# Great Western Highway Upgrade Program – Little Hartley to Lithgow (West Section)

Submissions Report

Transport for NSW | April 2022

Figure 3-1: Hartley Historic Site curtilage and land subject to revocation

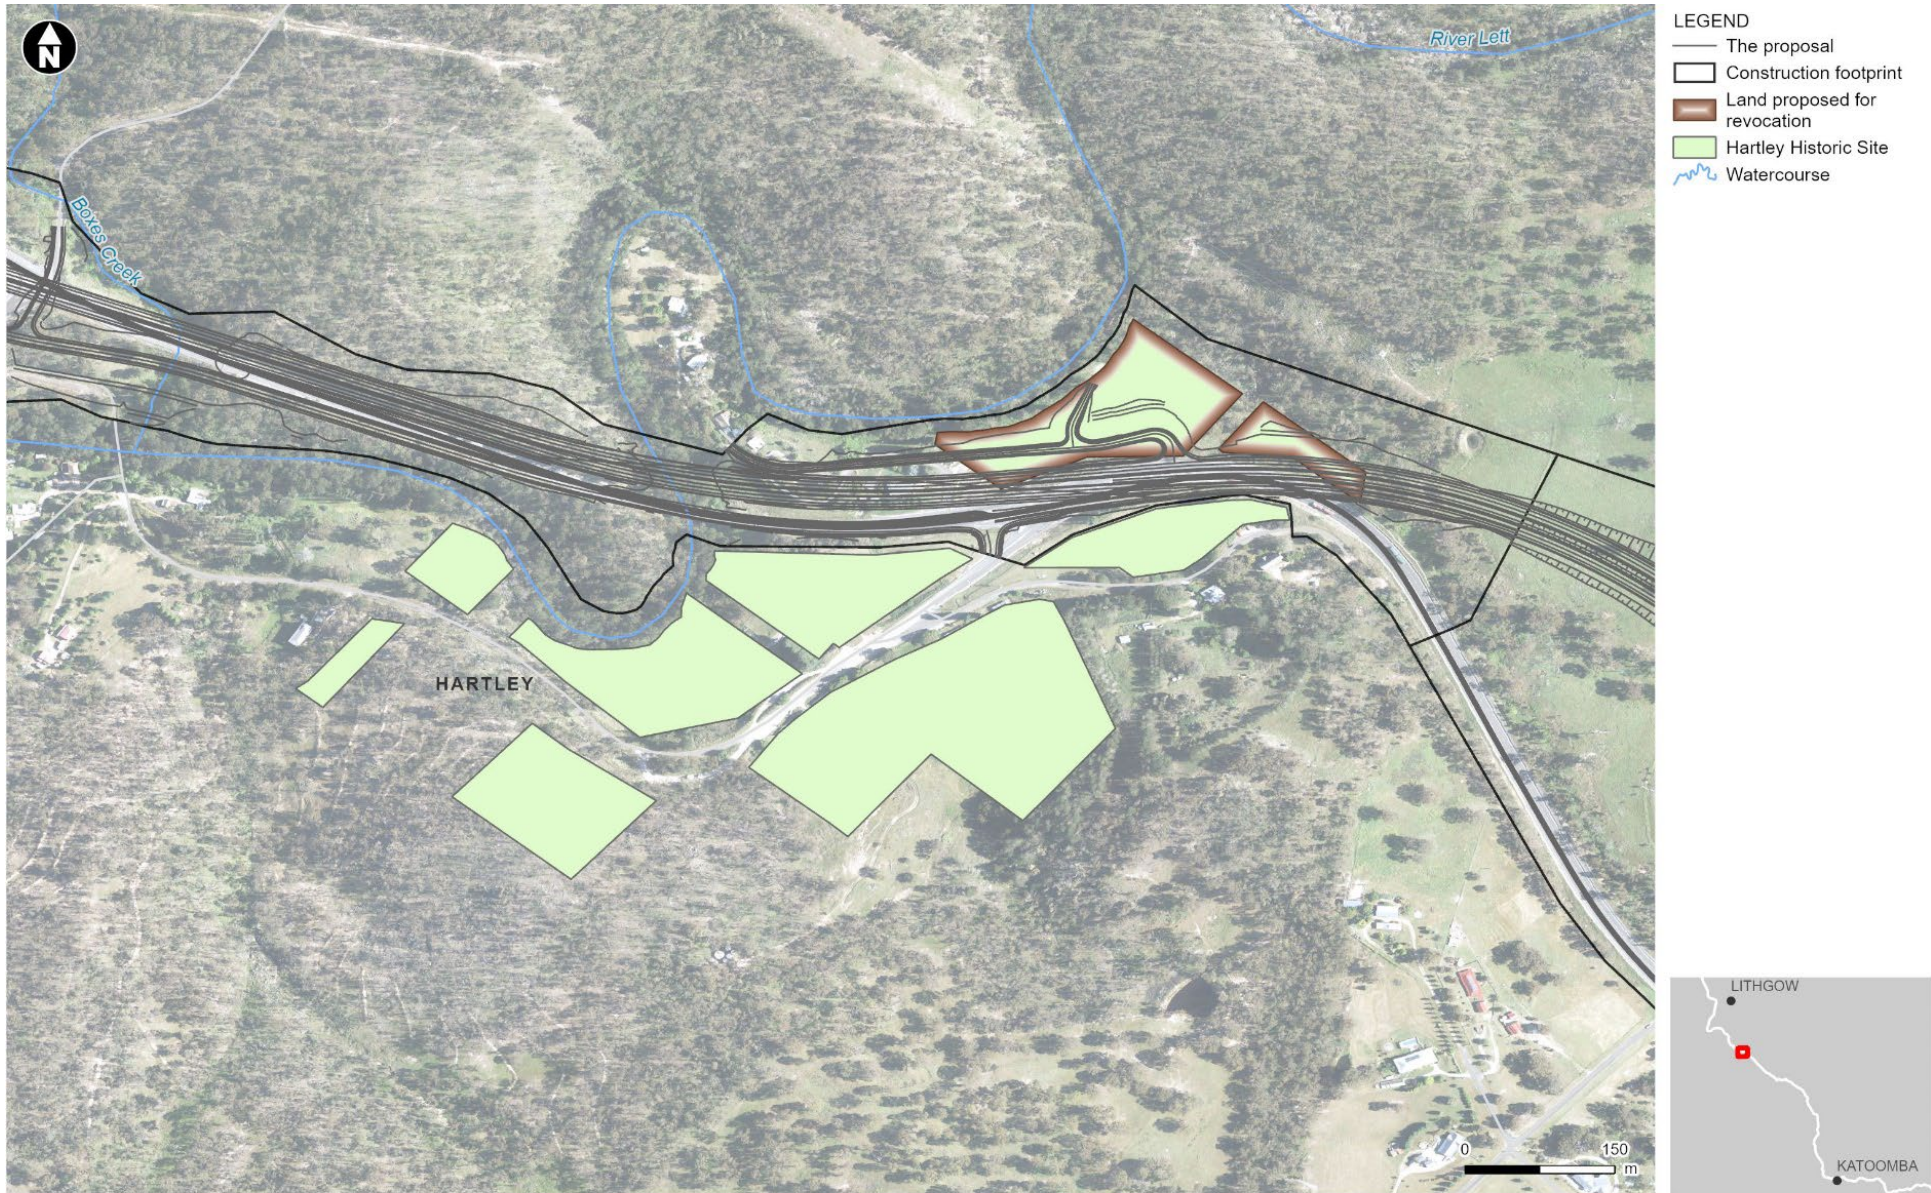
NPWS estate is not correctly identified in the REF. For instance, Figure 3-1 d (p. 25) appears to contain the following errors:

The mapping associated with the REF does not provide clarity on these concerns. For instance, Figure 3-3 b Proposal construction footprint (p. 48) shows a proposed construction footprint that appears to encroach onto the area of park not proposed for revocation (i.e. to the south of the existing highway alignment). It is not even clear from the mapping given the scale and quality of the maps exhibited whether the former Royal Hotel is excluded from the construction footprint. Similarly, Figure 1-3 Subject land (p. 26) in the Biodiversity Development Assessment Report (BDAR) (Appendix D of the REF) does not clearly exclude NPWS estate from “subject land”, which is defined in Section 1.2.1 of the BDAR (p. 25) to include the construction and operational footprints of the proposal.

It is acknowledged Figure 3-1d of the REF identifies the LEP heritage of the Hartley Historic Site however incorrectly states this land is NPWS land. The SHR curtilage that is NPWS land is identified and assessed in Figure 6-19, Section 6.5 and Appendix H of the REF. For clarity, the SHR curtilage is also shown in Figure 3-1 of this submissions report.

The land to be revoked is also identified in Figure 3-1 of this submissions report.

The proposal construction and operational footprint is shown in Figures 3-3 a to d of the REF. For clarity, Figure 3-1 in this submissions report shows the proposal and the construction footprint in relation to the SHR heritage curtilage of the Hartley Historic Site. Other than land proposed for revocation, no other land within this curtilage or other land reserved un under the NPW Act would be directly impacted by the construction or operational footprints of the proposal.

Figure 3-1 provides more detailed mapping of the subject land / construction and operational footprint of the proposal at the Hartley Valley Historic Site, based on the mapping shown in Figure 3-3b of the REF and Figure 1-3 of the BDAR.

Figure 3-2: Utilities in the vicinity of the Hartley Historic Site

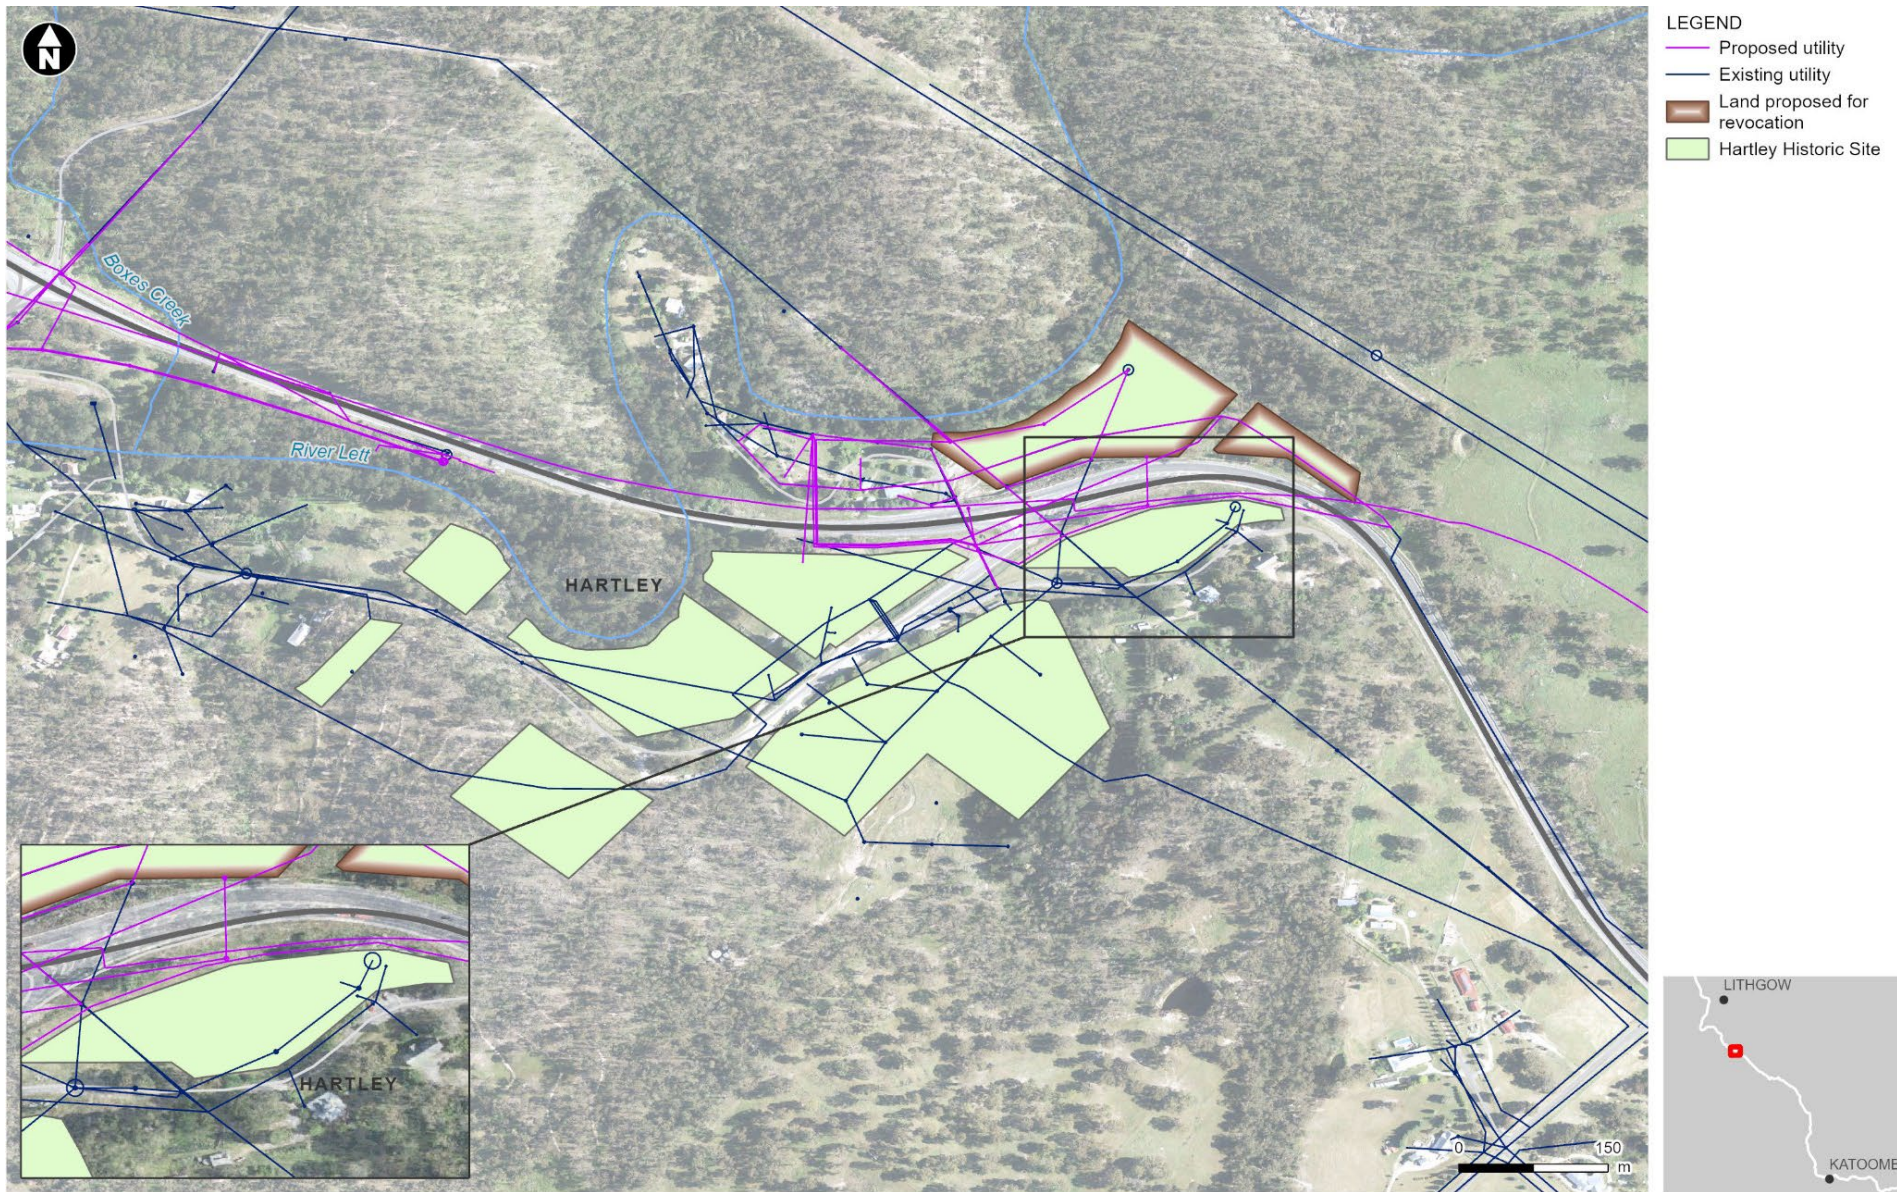
The existing and proposed utilities mapping (Figure 3-4 c Existing and proposed utilities, p. 70) is also unclear. It appears to depict significant infrastructure traversing Hartley Historic Site south of the current highway alignment however given the map quality it cannot be determined whether the mapped utilities are existing (retained) or proposed.

The existing utilities within the Hartley Historic Site to the south of the current highway alignment would not be impacted. Any utilities adjustments would be carried out within the construction footprint only, as shown with greater clarity in Figure 3-2.

Figure 3-3 Vibration impacts at the Hartley Historic Site

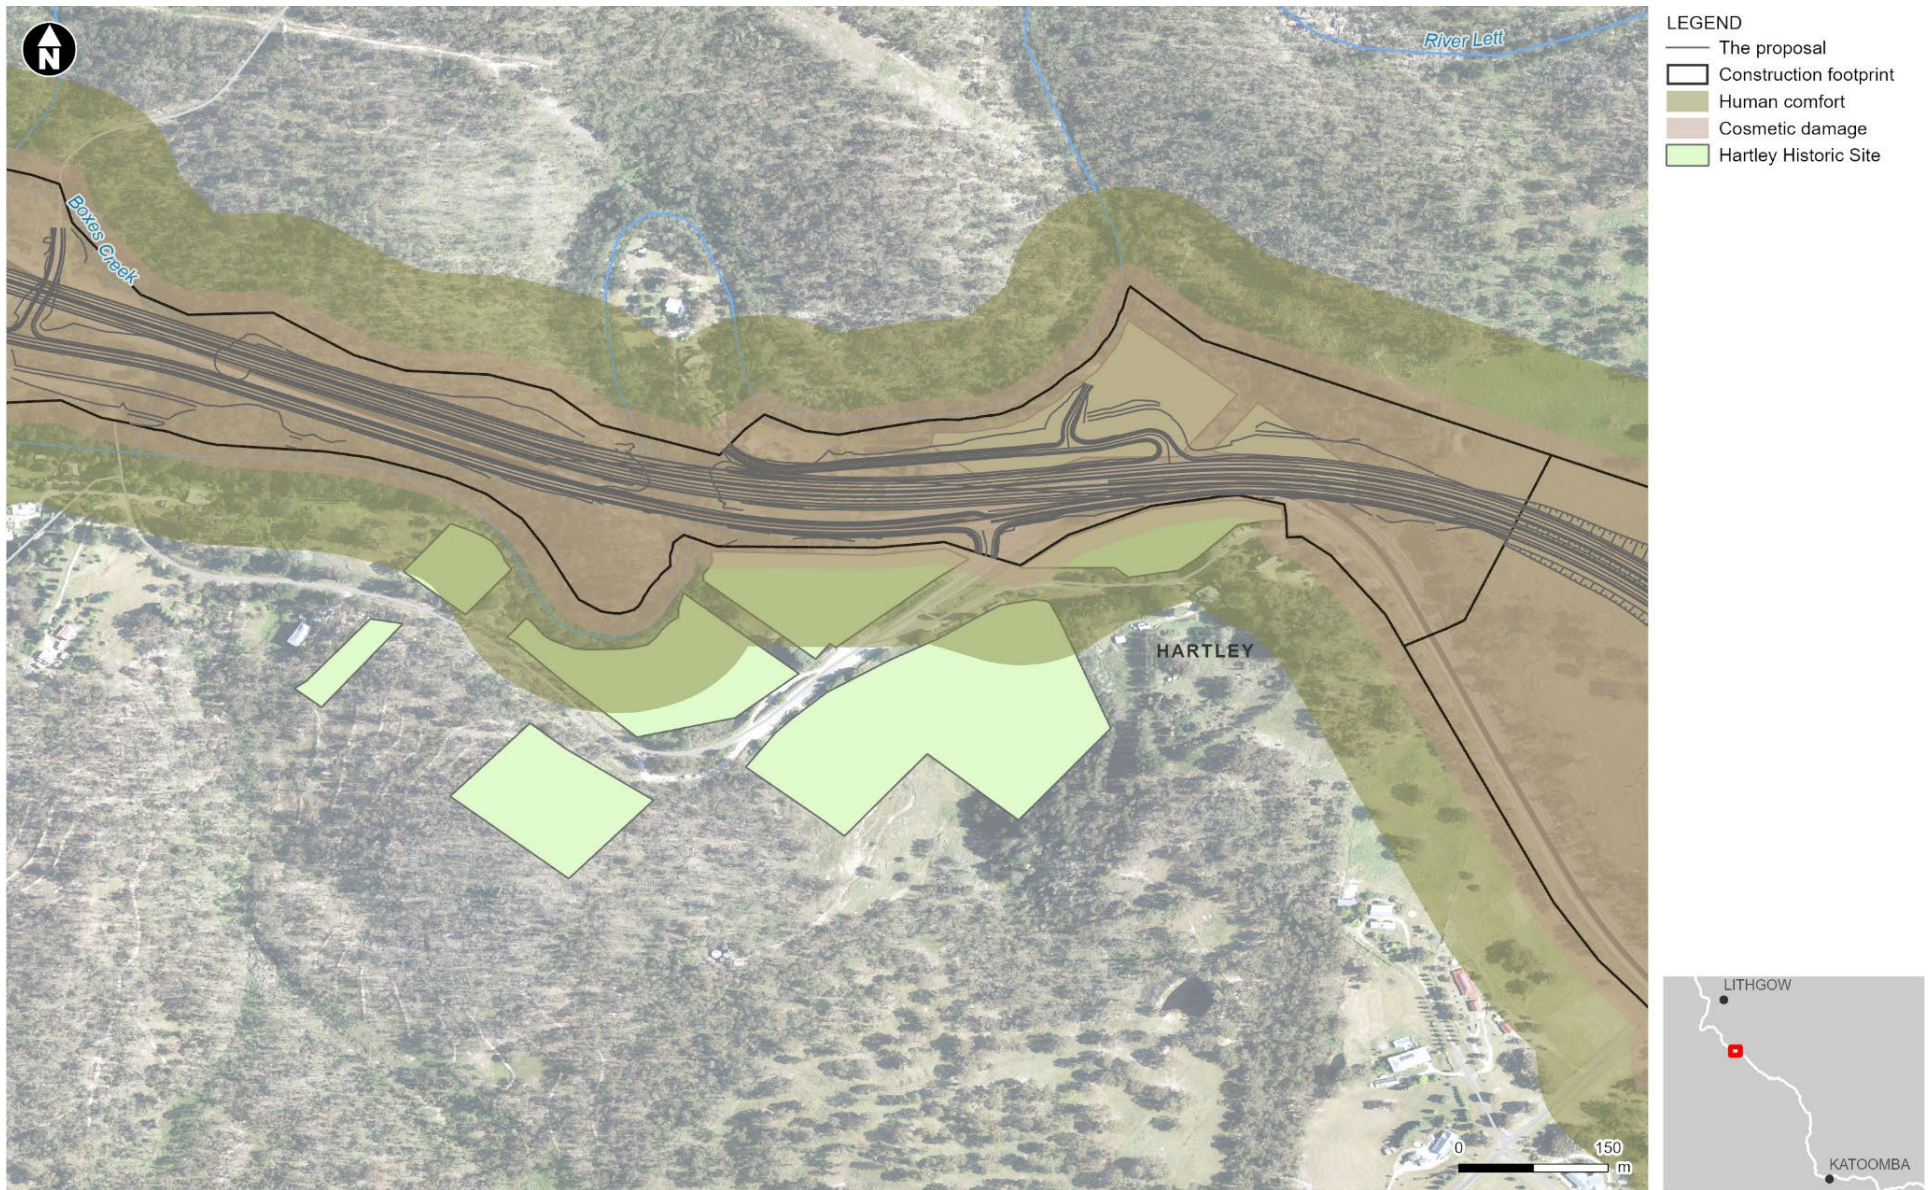
Concerningly, Figure 6-9 (Construction vibration assessment – Little Hartley to River Lett and Coxs River Road, p. 210) appears to show both road infrastructure and the cosmetic damage zone encroaching into the area of Hartley Historic Site south of the current highway alignment. Impacts to the historic site should be firstly avoided and, if not possible to avoid, mitigated. The REF does not demonstrate that this process has been followed given the cosmetic damage zone appears to encroach NPWS estate.

All proposed works would occur within the proposal construction footprint and would not directly impact the area of Hartley Historic Site south of the current highway alignment, as shown in Figure 3-1. As discussed in Section 6.3.3 of the REF, potential impacts during vibration intensive work have been assessed using the CVNG minimum working distances for cosmetic damage and human response. There are some areas of the Hartley Historic Site that are within the minimum working distances for cosmetic damage and mitigation will be required to be considered. Figure 3-3 provides more detail of the predicted vibration impacts on the Hartley Historic Site. Construction equipment that may cause vibration impacts would not occur on the boarder of the construction footprint, therefore serious impacts aren't expected.
